AZUCENA STREET
30-INCH SEWER PROJECT

SAWS Job. No. 11-4518
SAWS Solicitation No. B-12-059-DD

ADDENDUM NO. 3

October 8, 2012

MAP No. 134-582,132-584 SHEET 12 OF 34

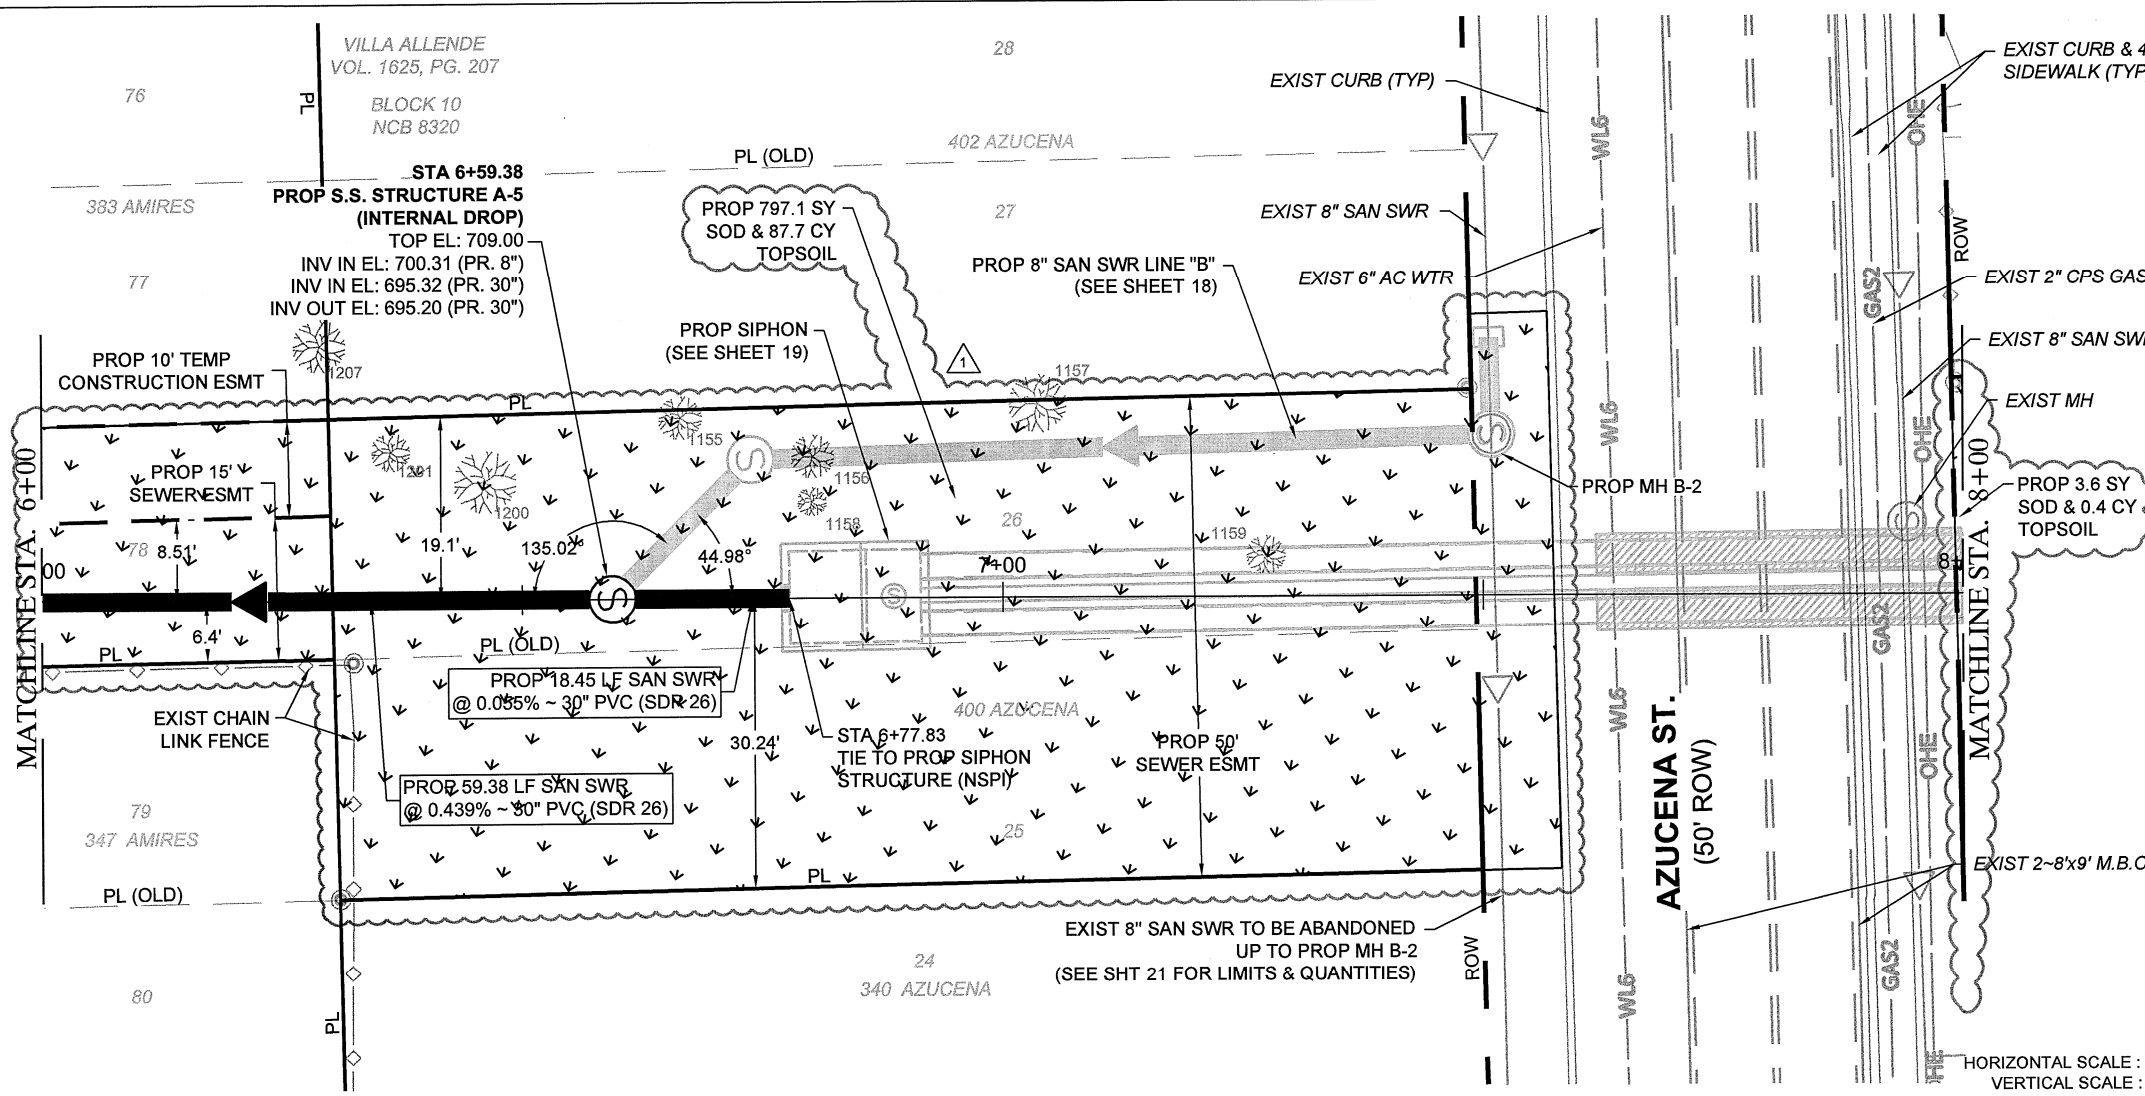
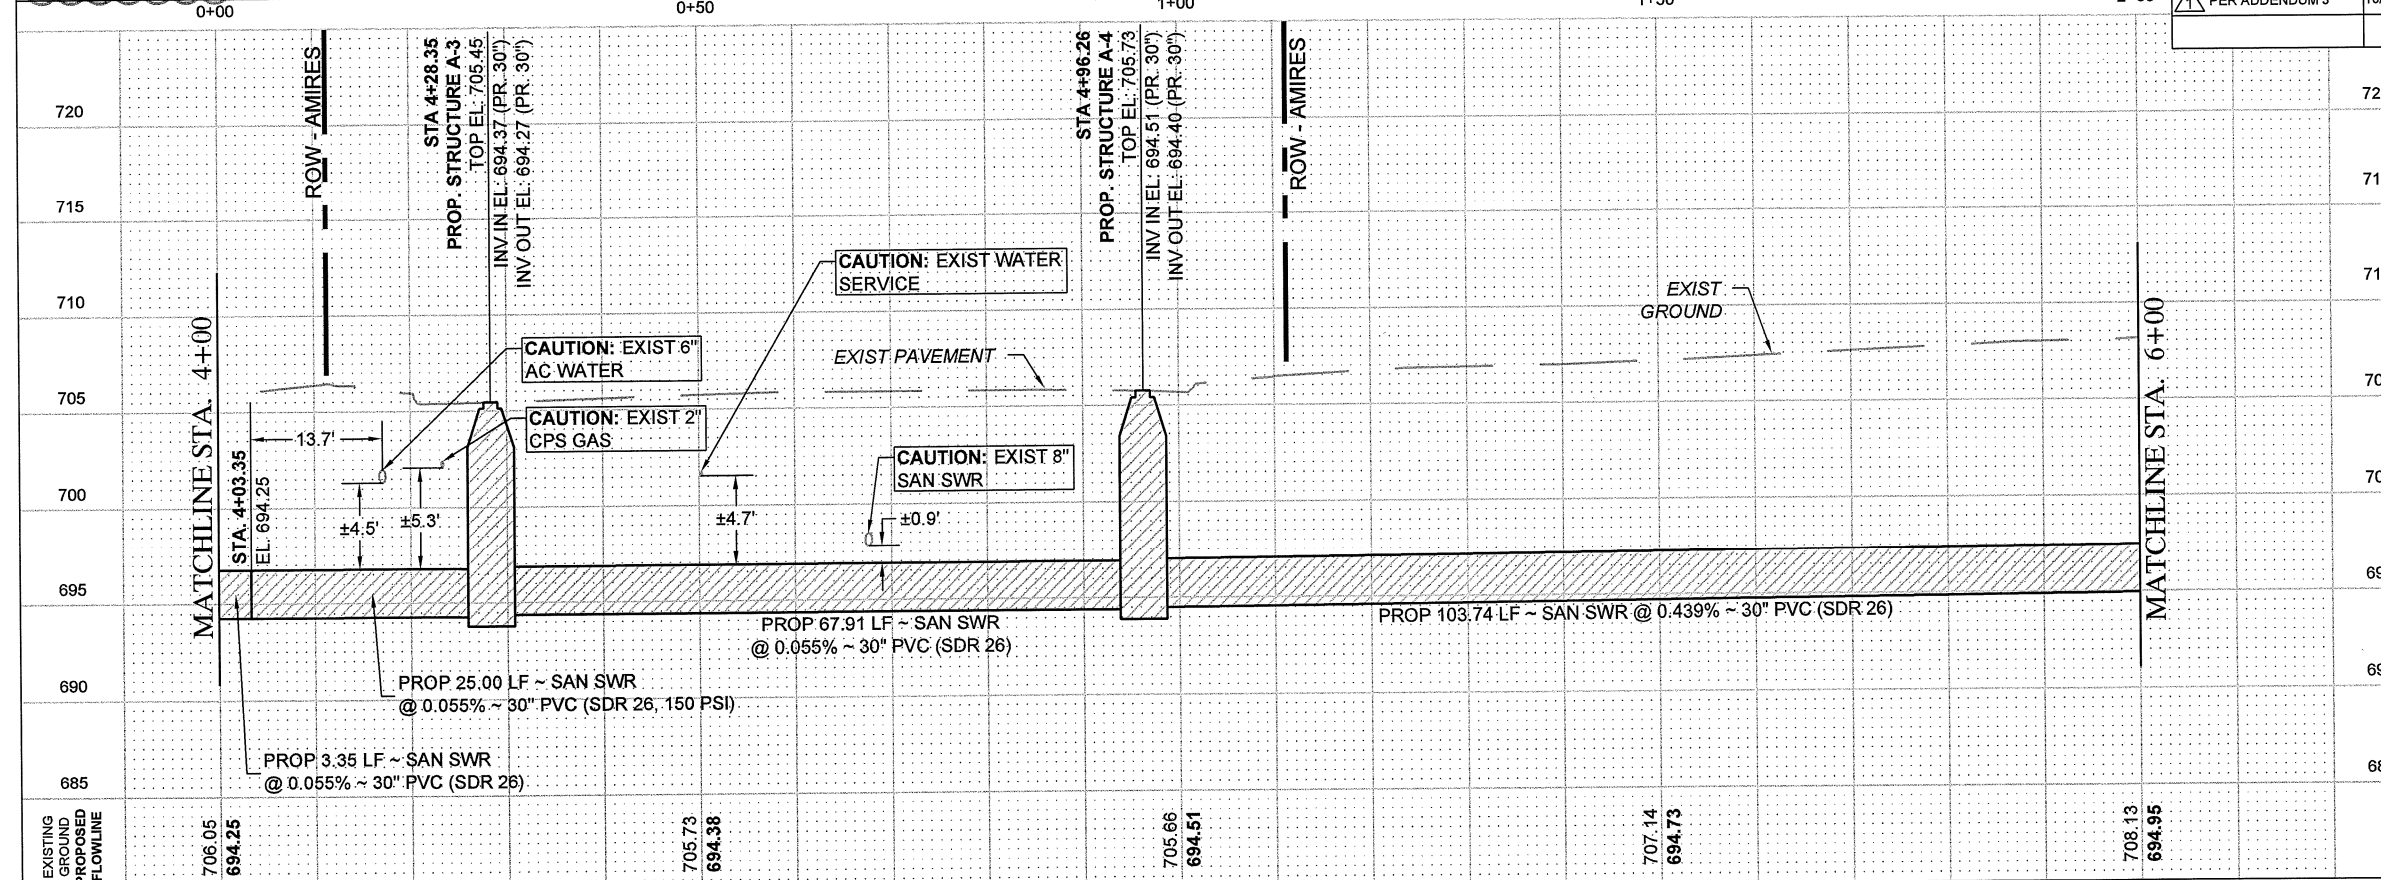
H. **Construction Plans – Sheet 12** – Remove in its entirety and replace with the revised “Sheet 12 – Line A – 30-Inch Sewer Plan & Profile – Sta. 4+00 to Sta. 6+00” attached.

MAP No. 134-582,132-584 SHEET
SECT. No. 13 OF 34
DR. MDS CK. MBH JOB No. 11-4518

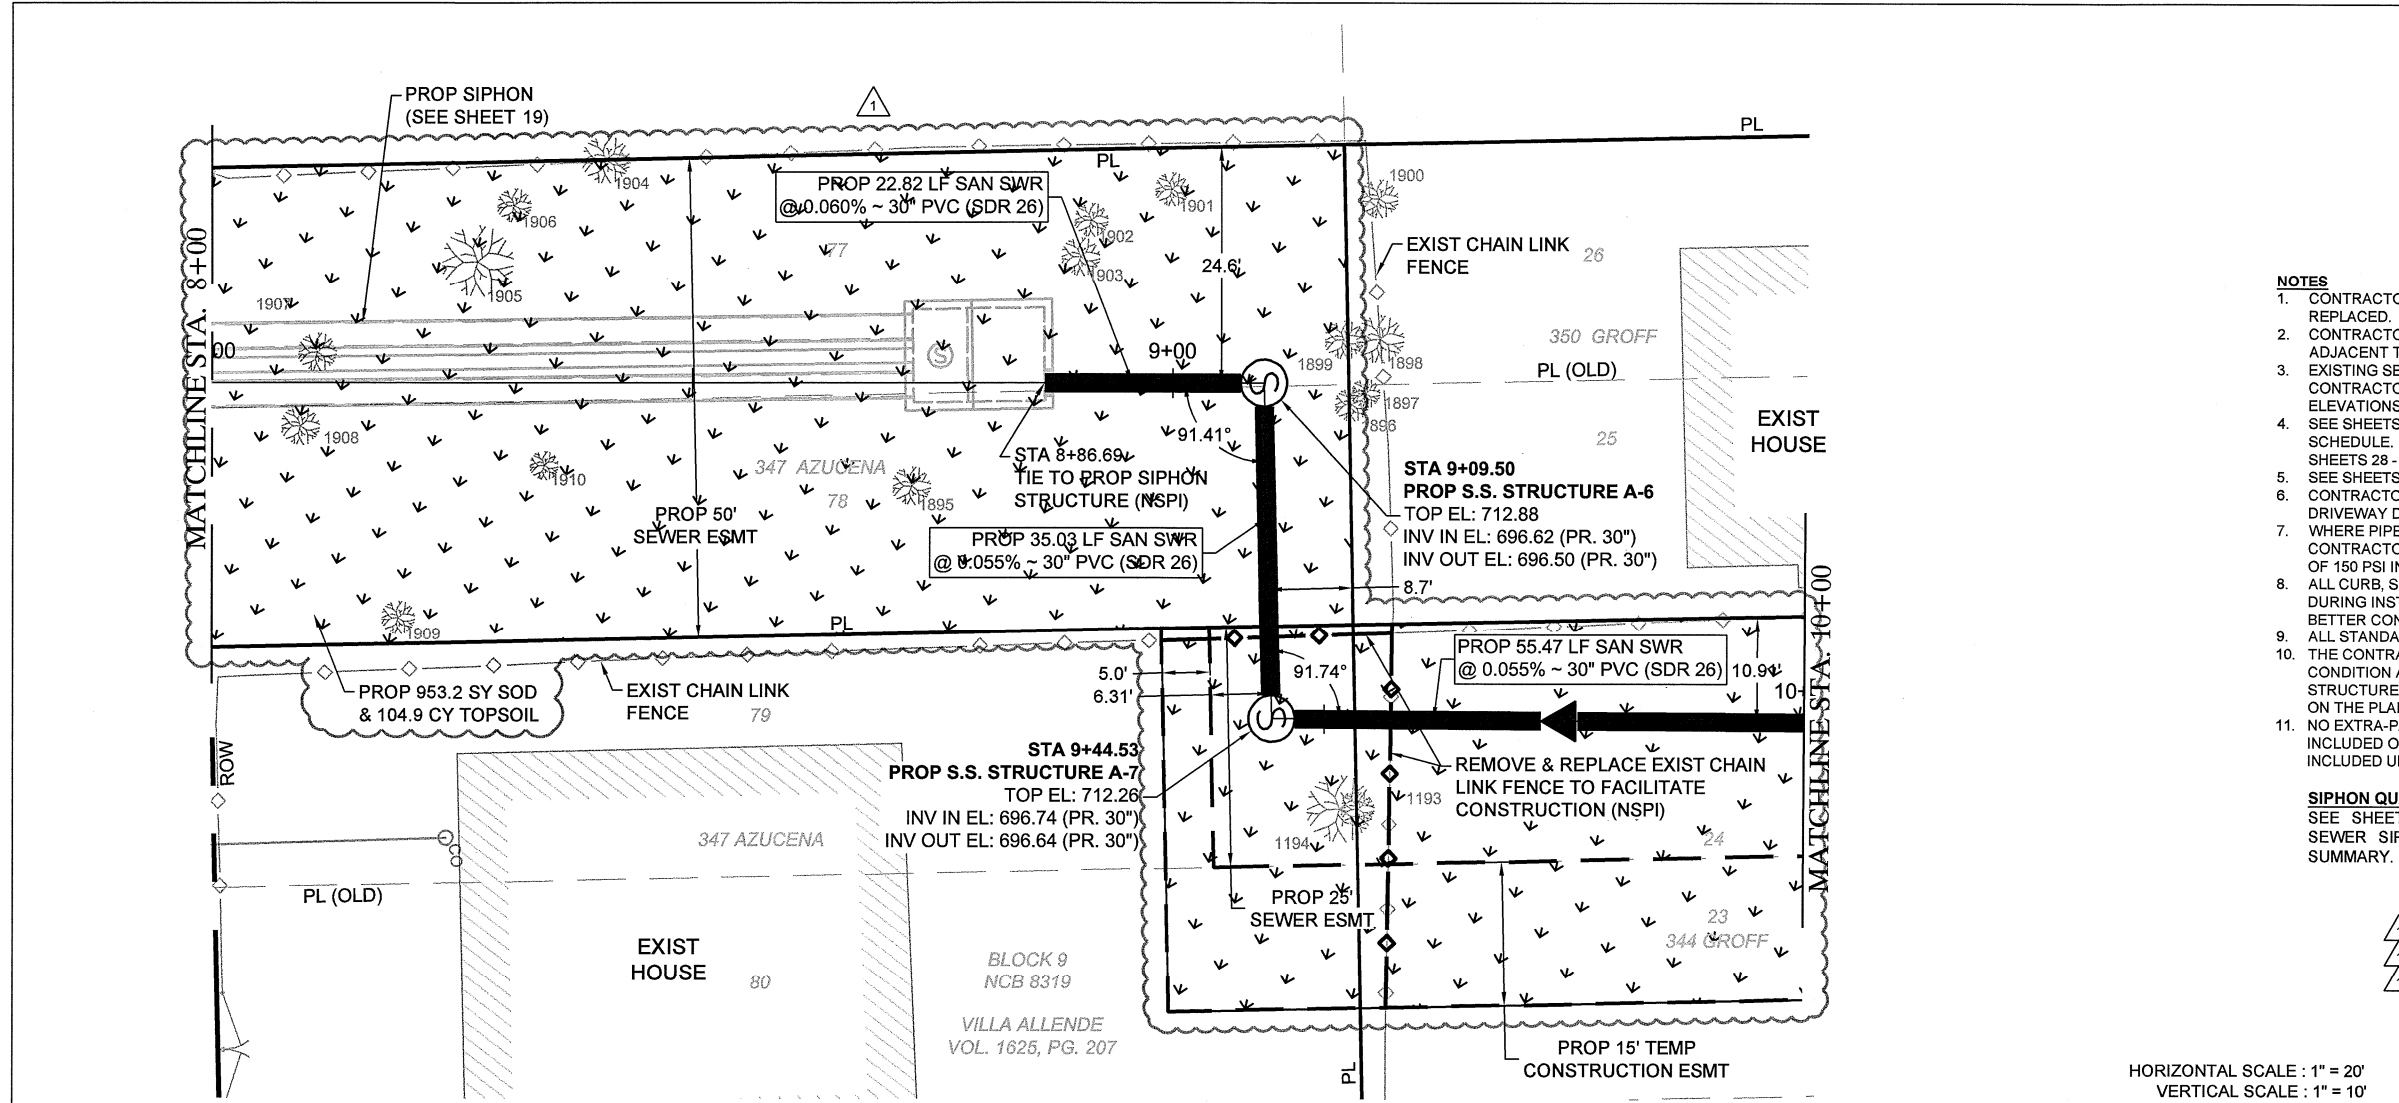
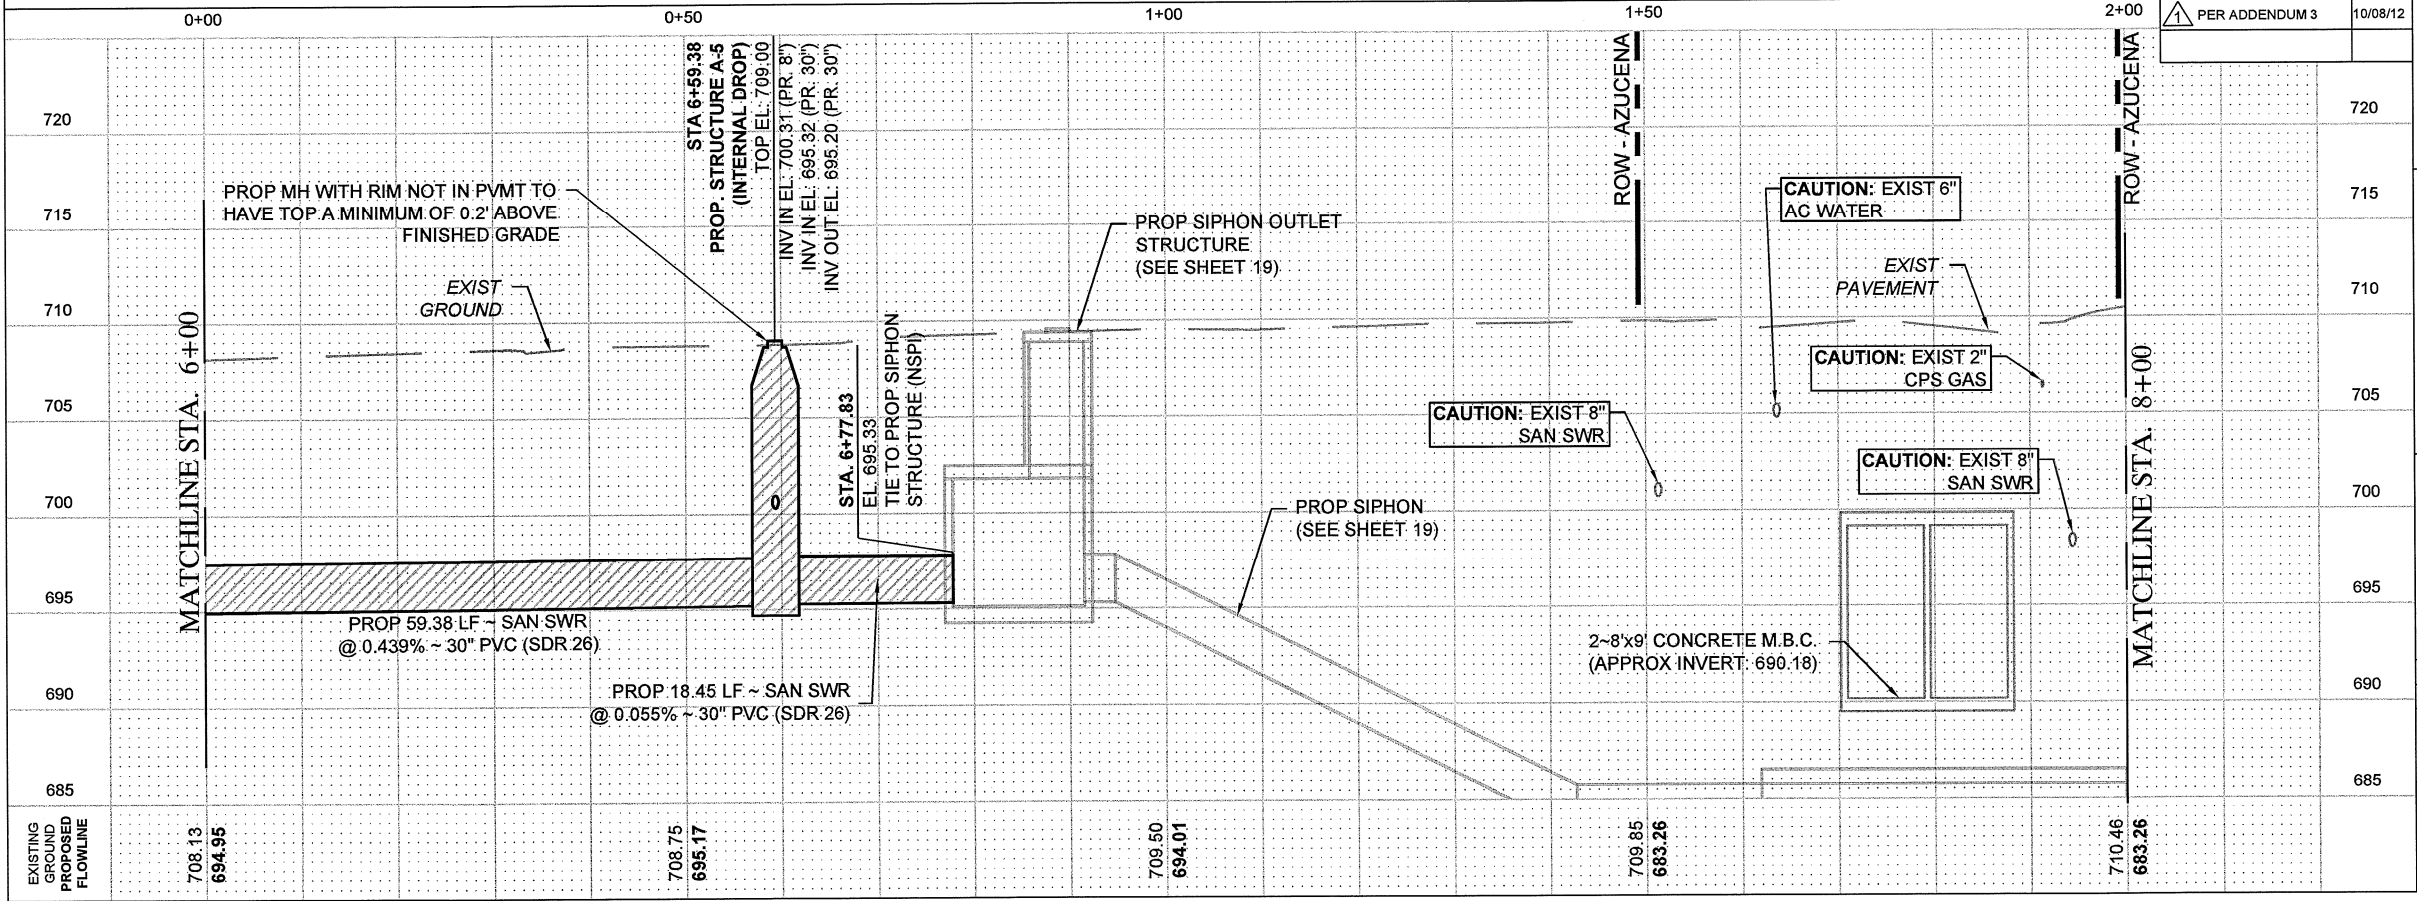
I. **Construction Plans – Sheet 13** – Remove in its entirety and replace with the revised “Sheet 13 – Line A – 30-Inch Sewer Plan & Profile – Sta. 6+00 to Sta. 8+00” attached.
